220 THORNTON LN.

SUMMARY

Applicant's Request:

Applicant is requesting a replat of the single
family lot for development of two single
family residential units.

BOUNDARY SURVEY

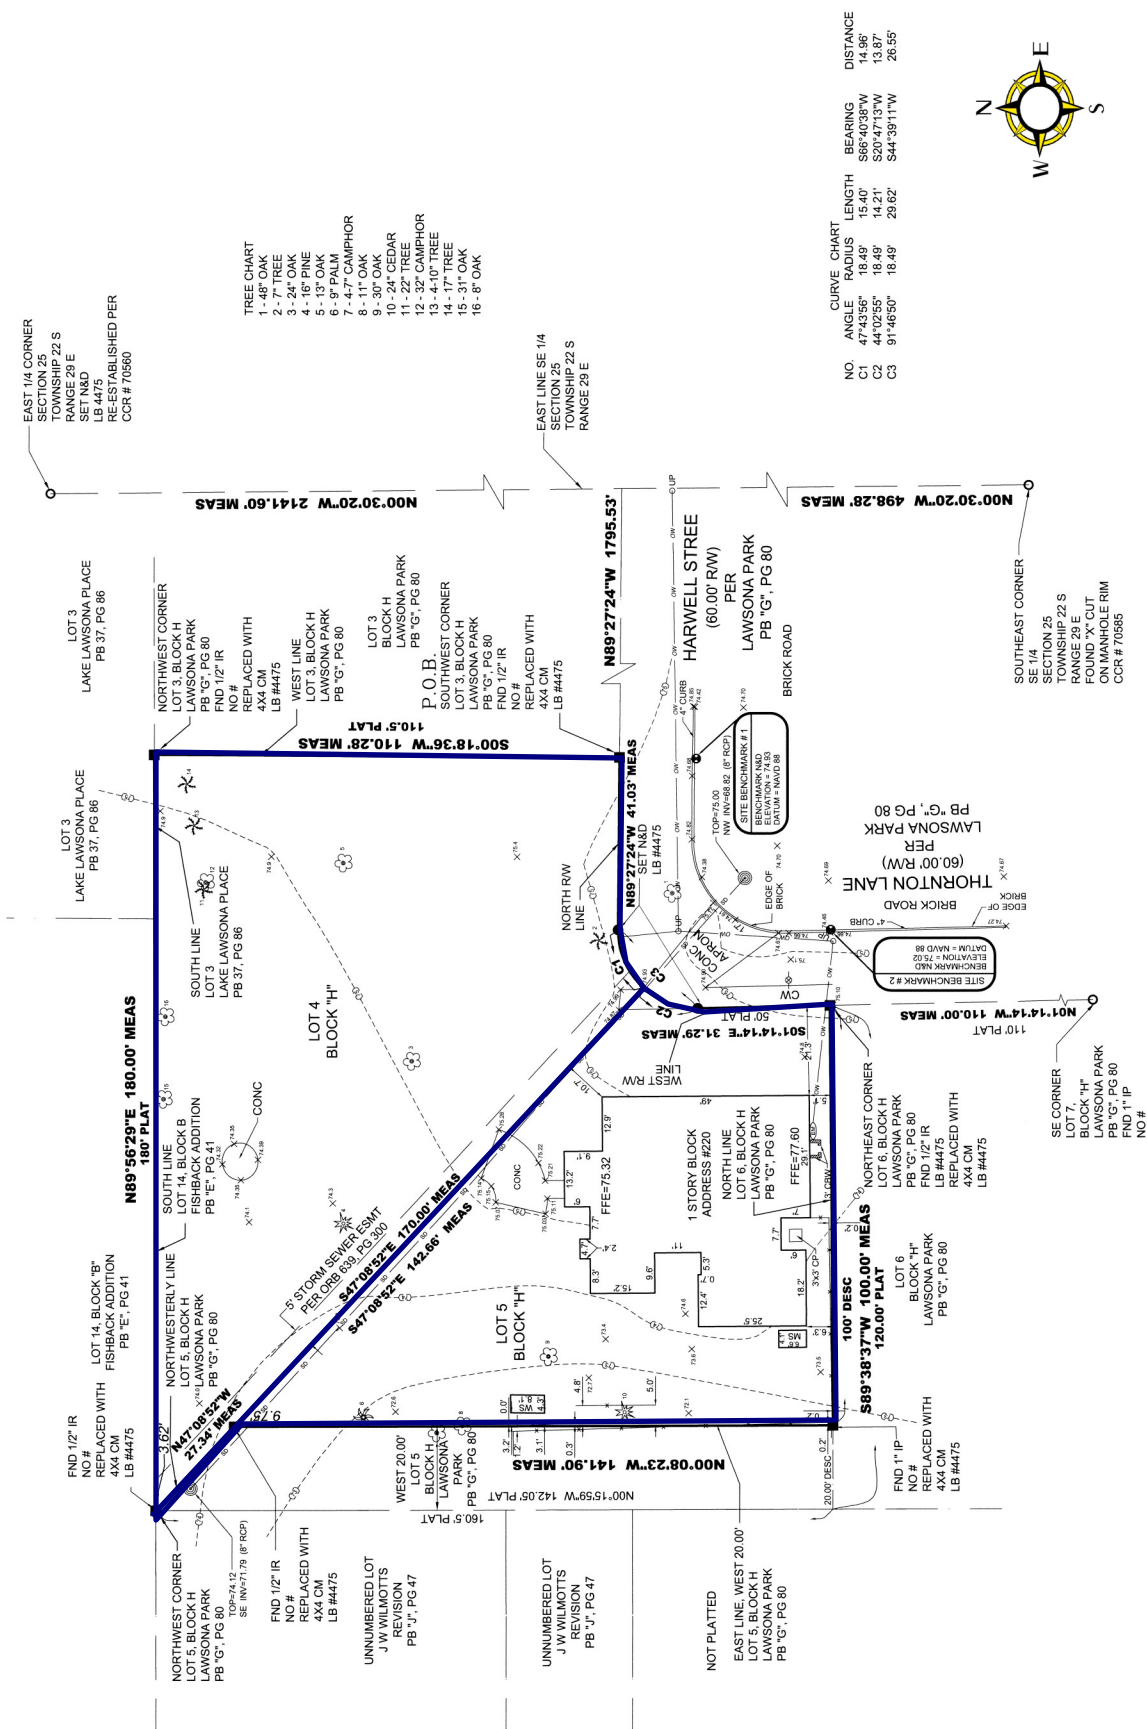
3. **Sheets1.** (Survey & Plat) Harwell Street is missing a letter T.
4. **Sheet1 :** (Survey) The manholes labeled storm manhole @ the NW & SE ends need to be changed to sanitary manholes..

5. **Sheet1:** (Survey) The comparison distances between the west line of block3, block H Lawsona Park PB G pg 80 ,the plat distance is 110.6' not 110.5'.

7. **Sheet 1:** (Survey) Vacate the existing 5' storm easement ORB 639 PG 300 and add the new 10' City Of Orlando sanitary easement in the dedication. FS 177.091 (16) (25)

PROPOSED PLAT

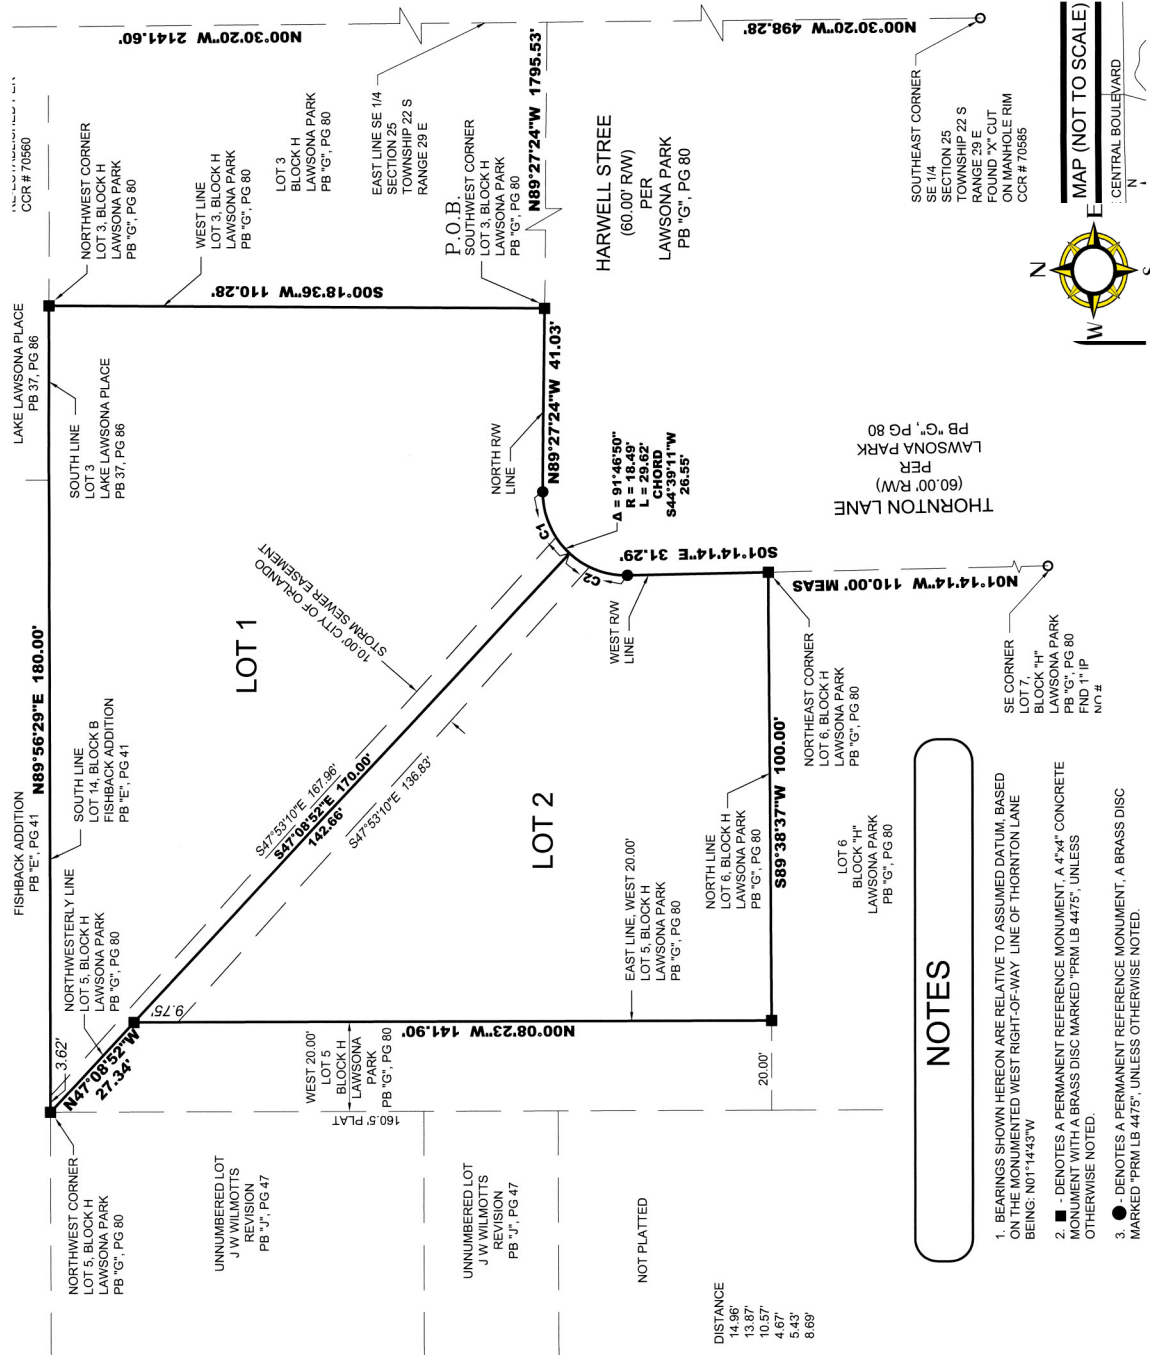
1. **Easement.** The proposed 10' wide easement shall be for sanitary sewer not storm. The easement shall be centered on the actual location of the existing sanitary sewer main.

1. **Sheets1.** (Survey & Plat) The notes of the west r/w line of Thornton Ln. are the same as
2. the bearings of the parcels descriptions. FAC 5J17.051 (9.) FS 177.091 (6)

6. **Sheet 1:** (Survey & Plat) There is a 5' sanitary easement along the west 20' lot 5 block H Lawsona Park PB G PG 80 that extends north threw lot 4 and into lot 14, block B of Fishback Addition PB E PG 41 and heads west .Deed Book 574 PG 466 .FAC 5J17.052 (2.)

8. **Sheet 1:** (Plat) A One In The Same Letter needs to be supplied.
9. **Sheet 1:** (Plat) The title opinion needs to reference the easement in comment # 5.

10. **Sheet 1:** (Plat) Chang the PRM BRASS DISC LB 4475 ON NORTH R/W line to a PRM 4X4 CM LB 4475 on the face of the plat as recovered.
11. **Field Review.** Field Review has passed. FS 177.091(7)
